Product Safety Recall

N202312100 Seat Belt Cable Separation – US Only

Release Date: November 2020

Revision: 01

4593189

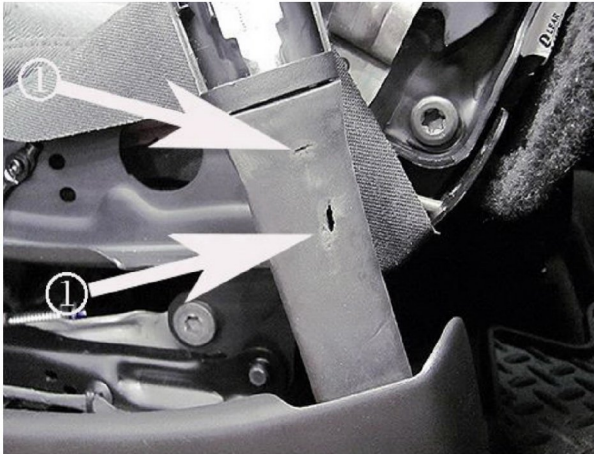
1. Using the seat adjustment switch, move the driver seat as far rearward and downward as possible. The front safety belt cable sleeve (hereinafter, “sleeve”) covers the flexible steel cable that connects the safety belt to the vehicle at the front outside seating position. The sleeve is covered by the seat trim and comes out of the slot on the side of the front seat.

2. Inspect the sleeve for any cuts or cracks. Bend the cable toward the inside and outside of the vehicle and inspect the area near arrows (1) above.

- If **any damage** is found, replace the tensioner and revised seat trim listed above. Refer to *Front Seat Belt Anchor Plate Tensioner Replacement* in SI.
- If no damage is found, only install the revised seat cushion outer finish cover.
